The request filed on 6/22/2011 for a Request for Continuing Examination (RCE) under 37 CFR 1.114 is acceptable and an RCE has been established. Any previous finality is hereby withdrawn and a new action on the merits follows. Any newly-submitted claims have been added. An action on the RCE follows.

Application/Control Number: 10/579,139

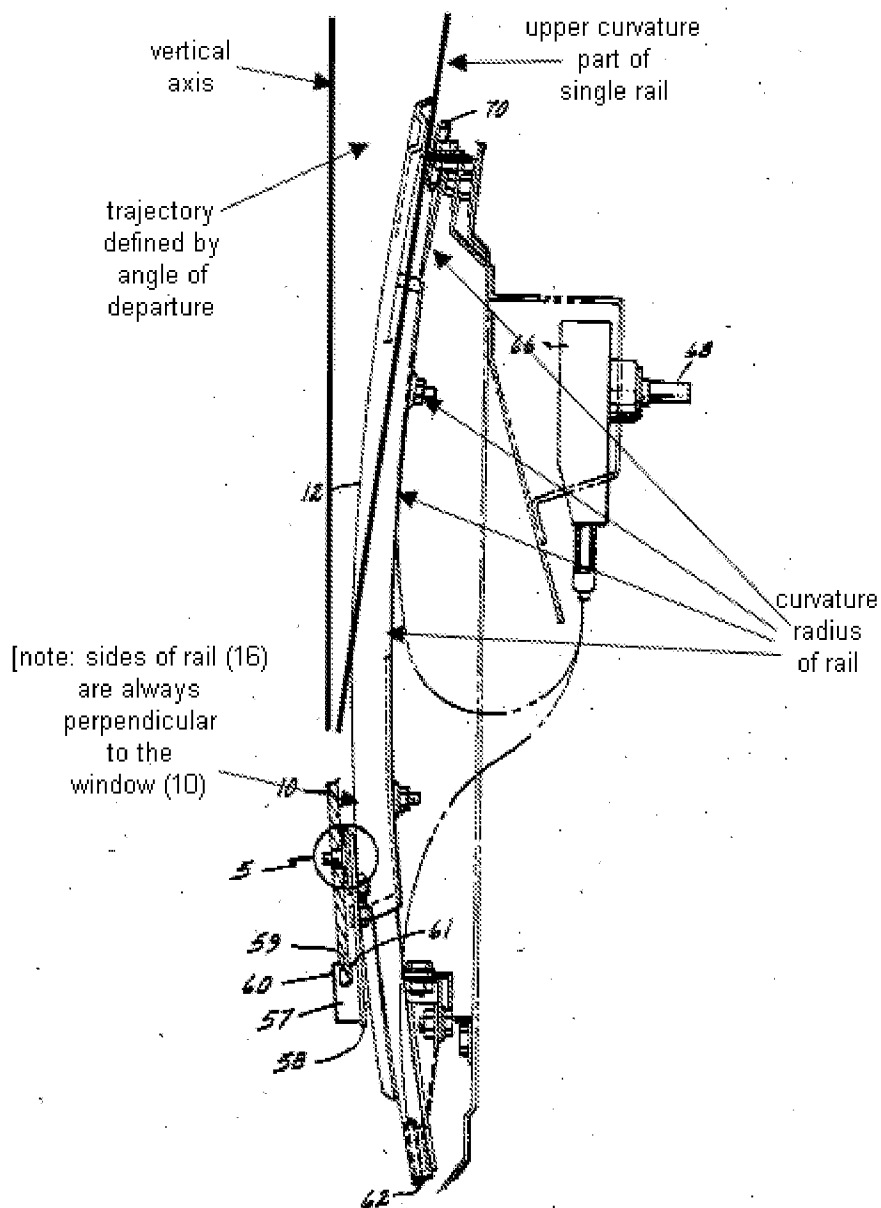
Claims 3 and 5-7 are rejected under 35 U.S.C. 102(b) as being anticipated by Bickerstaff (4,589,227). As shown below, Bickerstaff (4,589,227) discloses an operating device for a vehicle consisting of at least one slider (25) joined to a window (10), the at least one slider (25) slides along a single guide rail (16), the guide rail (16) defining a curved trajectory (see Figure 2) which the window (10) follows during operation of the device (moves between 10a and 10b via cable (62) [claim 6]), the trajectory being determined by an angle of departure formed by a vertical axis and an axis defined by an upper curvature part of the rail (16) and by a curvature radius of the rail (16) with the side of the rail (16) being perpendicular to the window (10) [claim 5], and means for

adjusting (slot 32) the position of the device with regard to a door of a vehicle wherein the angle of departure is between + 45 degrees and -45 degrees wherein the means has two lateral screws (extending within slot 32) for lateral adjustment, and at least one screw (see figure 5) on the slider which allows the position of the window (10) to be adjusted with regard to the rail (16) and the slider. [note: the thickness of the plates (52, 56, 58, 48, and 50) allows the thickness between the window (10) and the slider to be adjusted]
